BOARD OF COMMISSIONERS OF THE PORT OF NEW ORLEANS
NOTE TO PERSPECTIVE BIDDERS
CONTRACT FOR
FRANCE ROAD TERMINAL AND JOURDAN ROAD
REPAIRS TO PUMP STATIONS P2-P5 AND
PATTERSON PUMP STATION
DAMAGE BY HURRICANES KATRINA AND GUSTAV

August 1, 2011

ADDENDUM NO. 3

DWG. NO. **M11-7123-W2** REC. 060397

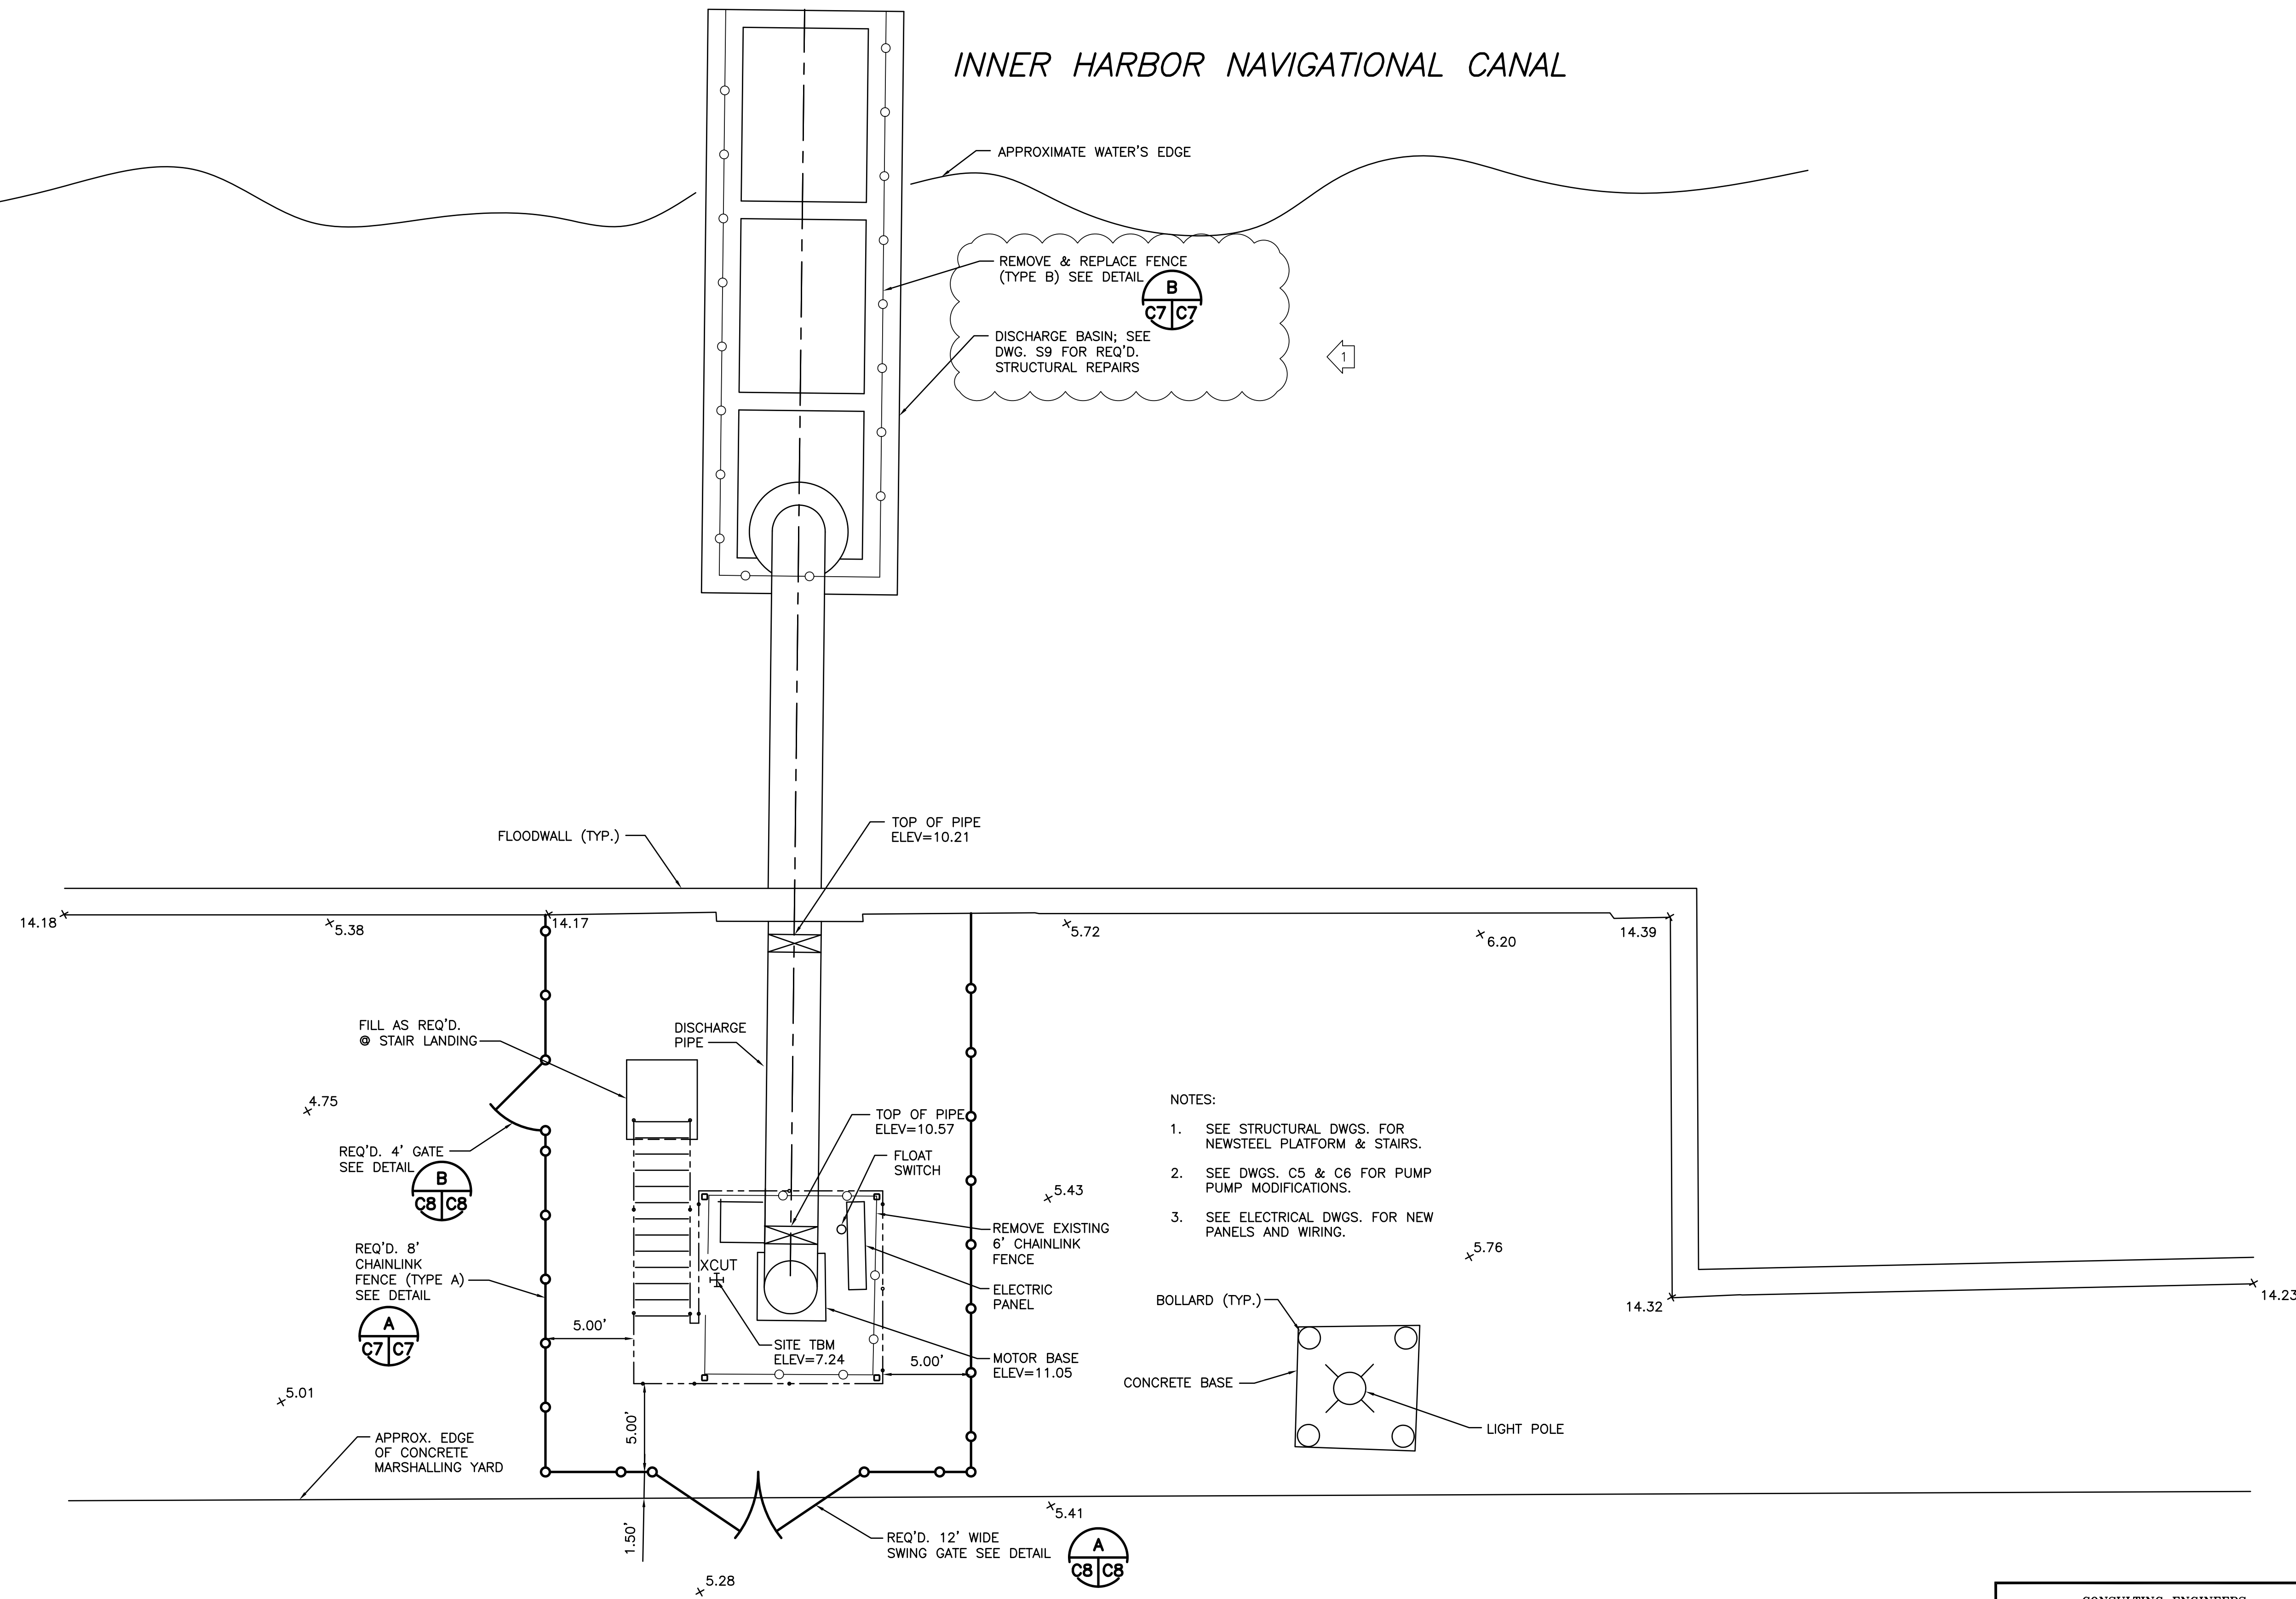
Q13: The Electrical Site Plan shows new underground duct bank from Pump Station P4 Generator to each of the other three (3) drainage pump stations. The plans show some existing underground utilities. There is a high probability that others exist beyond that shown. LA One Call does not locate utilities on private property. Please address.

SEQUENCING NOTES

1. ONLY ONE (1) PUMP CAN BE TAKEN OUT OF SERVICE AT A TIME WITHOUT PROVIDING TEMPORARY PUMPING. TEMPORARY PUMPING CAPACITY (TPC) OF 7,000 GPM MINIMUM PER ADDITIONAL PUMP STATION SHALL BE PROVIDED IF CONTRACTOR ELECTS TO SHUTDOWN MORE THAN ONE (1) PUMP STATION AT A TIME.

Answer: See Civil General Note 3 on Dwg. W2.

REVISED SEQUENCING NOTE
 ADDENDUM NO. 3
 DATE 8/1/11

DWG. NO. **M11-7123-C6** REQ. 060397

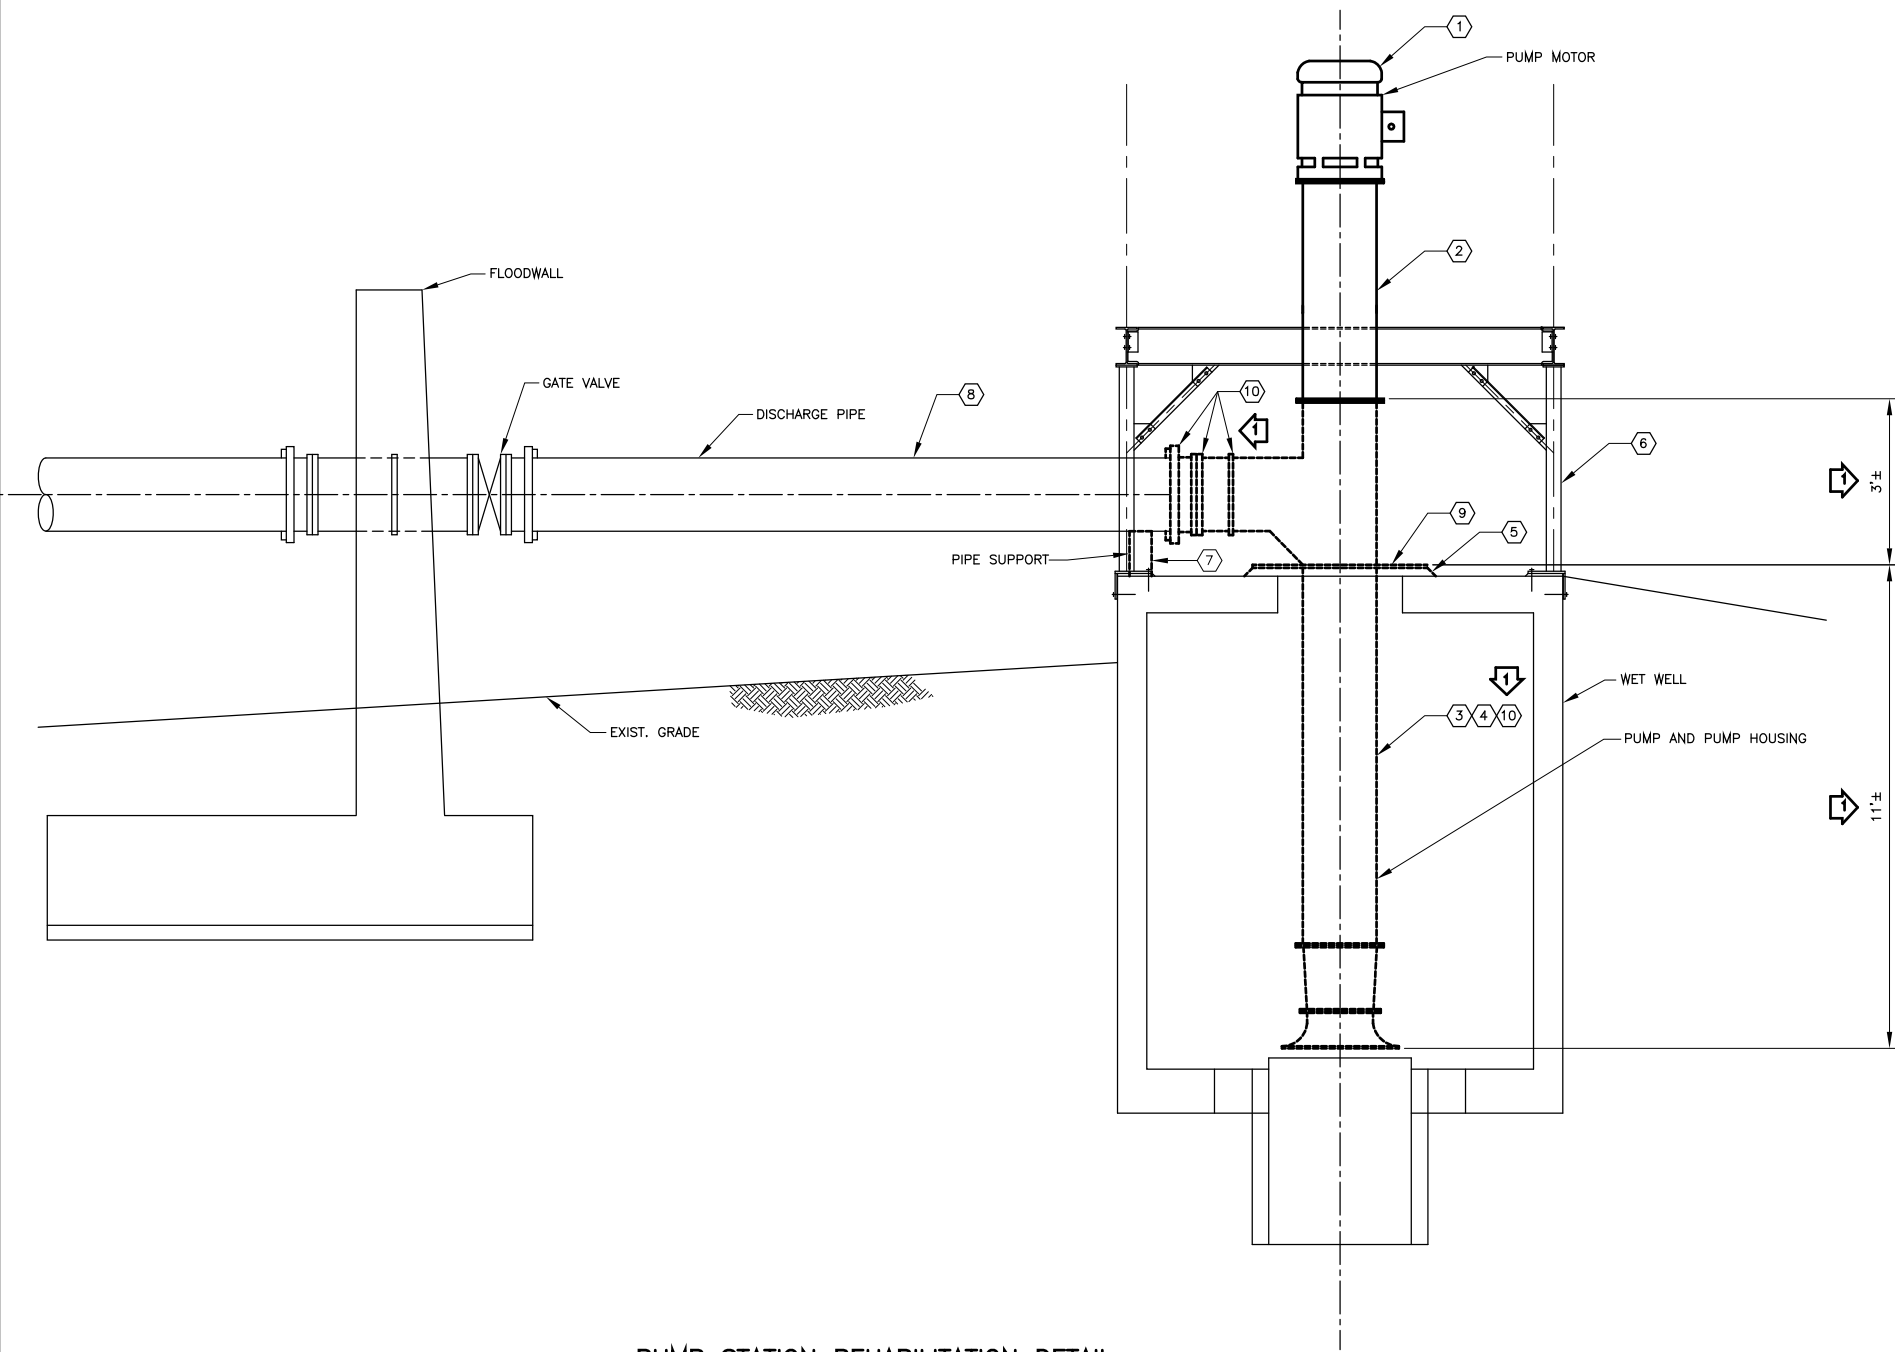
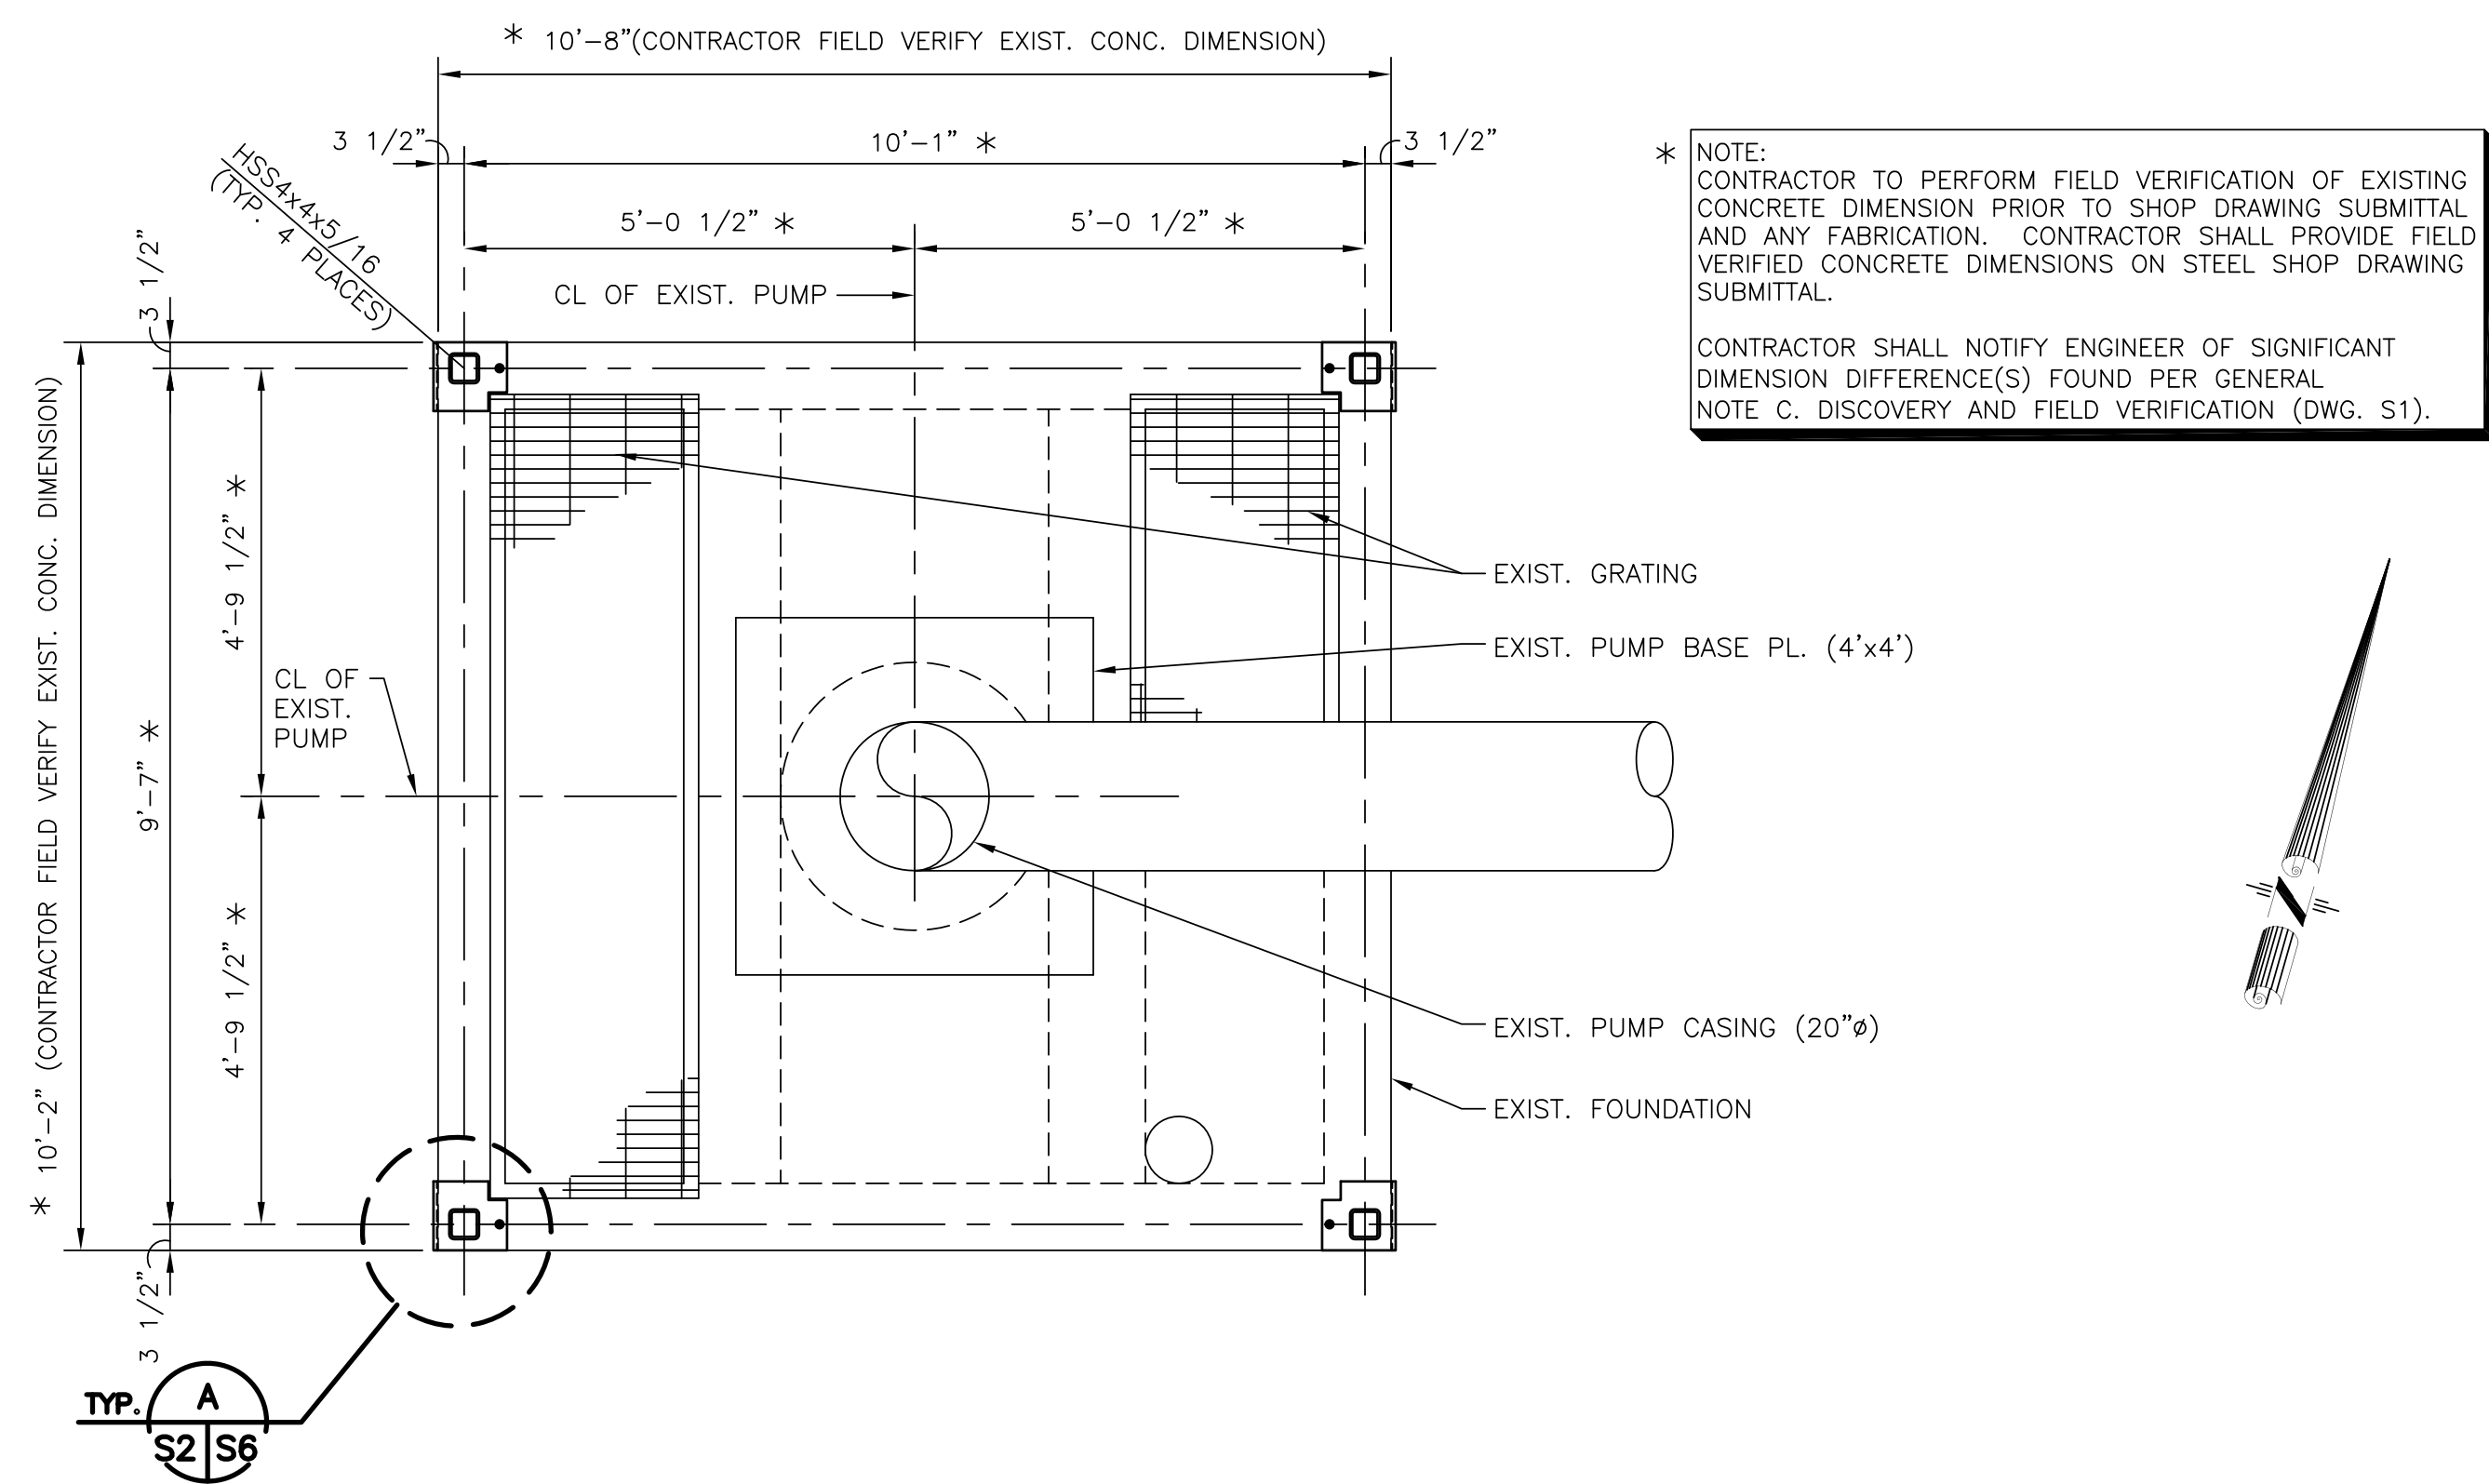
Q3: In order to remove the existing pumps for inspection, the existing nuts, bolts and studs connecting the pump discharge flanges to the check valves will need to be removed. Most of them are rusted and deteriorated. There are no provisions in the Specs for replacing them. Should we re-install the old bolts and nuts onto the freshly painted pump flanges or should we provide new nuts, bolts and studs? If new are required, what should they be, black, plated or stainless?

Q5: Plan Sheet C-6, Note 2, requires a grout bed to be installed prior to leveling and shimming the pumps. The pump needs to be leveled and shimmed prior to placement of the grout. Please clarify.

Answer: The Contractor will be required to replace the bolts and/or threaded restraint rods and nuts connecting the pump discharge flanges to the check valve. See Item No. 16 below.

Answer: Note 2 on Sheet C-6 is being revised. See Item No. 16 below.

1. AT PUMP STATION 3 (P3), REINSTALL ORIGINAL MOTOR.
2. CONTRACTOR SHALL SHIM AND LEVEL PUMP DISCHARGE ELBOW TO MATCH LEVELED DISCHARGE PIPE AND SO PUMP COLUMN IS PLUMB. AFTER SHIMMING AND TIGHTENING OF ANCHOR BOLTS, THE BASE PLATE SHALL BE "GROUTED IN" USING AN APPROVED NON-SHRINK GROUT MIX AND SHIMS COMPLETELY ENCAPSULATED THEREIN IN SAND GROUT. MOTORS SHALL NOT BE INSTALLED UNTIL GROUT HAS CURED FOR AT LEAST SEVEN (7) DAYS.

REVISED NOTES, LEGEND AND PUMP STATION REHABILITATION DETAIL ADDENDUM NO. 3
 DATE 8/1/11
